UNITED STATES PATENT AND TRADEMARK OFFICE

APPLICATION NO.	FILING DATE	FIRST NAMED INVENTOR	ATTORNEY DOCKET NO.	CONFIRMATION NO.
10/776,206	02/12/2004	Tian-Fu Cao	MR3287-11	4173

<p align="center">Office Action Summary</p>	<p>Application No.</p> <p>10/776,206</p>	<p>Applicant(s)</p> <p>CAO, TIAN-FU</p>	
	<p>Examiner</p> <p>Flemming Saether</p>	<p>Art Unit</p> <p>3677</p>

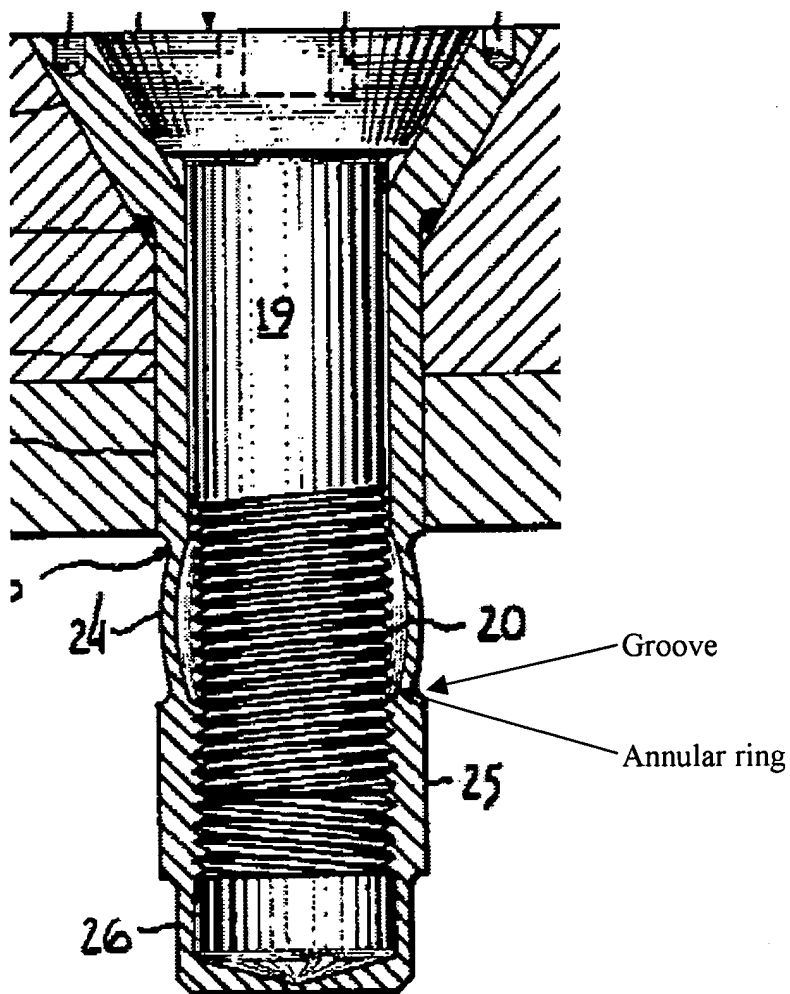
Claims 1, 2 and 4 are rejected under 35 U.S.C. 103(a) as being unpatentable over US Patent No. 3,136,203 to Davis in view of applicant's prior art as seen in Figs 1 and 2 (APA). Davis discloses a "bund nut" comprising a flange (21) at one end of a duct

having first (24) and second (25) areas. The first area being closer to the flange and having a greater space then the second area such that an inclined annular ring and peripheral groove (see below) are formed at the same location between the first and second areas. The second area being threaded and a latch (16) is formed adjacent the first area.

Applicant argues that Davis does not disclose a ring portion as indicated in the figure since what is indicated is simply the upper portion of the thread. In response, the examiner disagrees because the arrow in the figure is meant to point to an area

adjacent the first thread but, that notwithstanding, even the surface of the first thread would read on the ring portion since that surface must extend to be larger than the periphery of the threaded surface for the device to be operable.
